Product Change Notification

TE Connectivity

Product Change Notification: E-14-009314

Superseal 1.5 series connector.

Product image before change

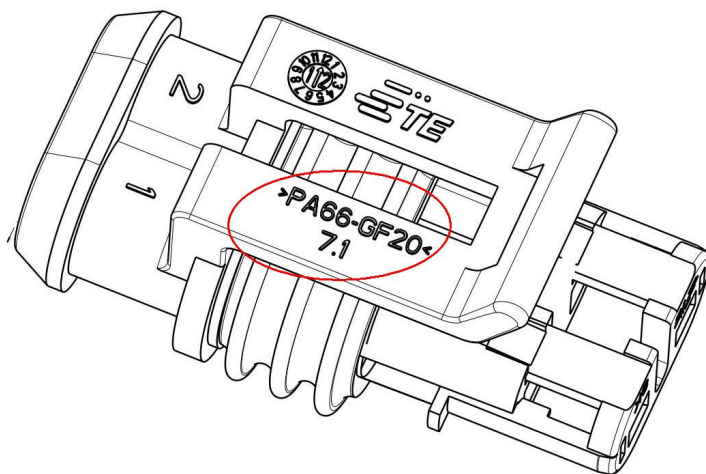
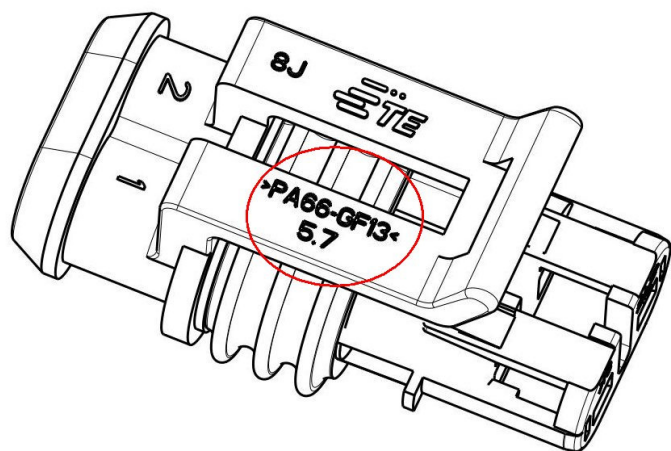
Material change. This change is considered by TE Connectivity as an improvement. Location of change, see material logo.

Product Improvement. PA66 20% GF material has to be replace the actual one (PA66 13% GF).
